**SITE PLAN REVIEW COMMITTEE
MEETING AGENDA**

Item 2. Rosslyn Plaza PDSP (SP #422) 7:00 pm – 10:00 pm
(RPC#s 16-039-010, -011, -012, -025, -032, -033, -034, -035, -036, & -037, and a portion of the Arlington Ridge Road right-of-way)
Planning Commission and County Board meetings to be determined.
Elizabeth Kays & Jason Beske (CPHD Staff)

ITEM 2
Rosslyn Plaza PDSP (SP #422)

Rosslyn Plaza PDSP Proposed Phasing Plan

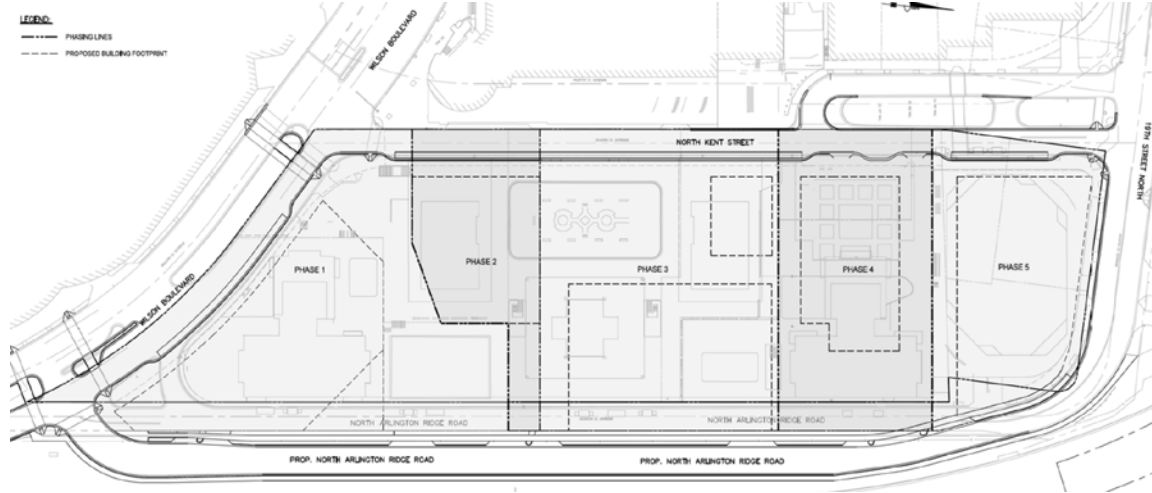
- c) The proposal should use creative solutions for topography.
 - d) Buildings should be designed with varied heights and massing.
 - 4) Phasing
 - a) The phasing plan should be developed so as to support the success of retail and public spaces in the interim.
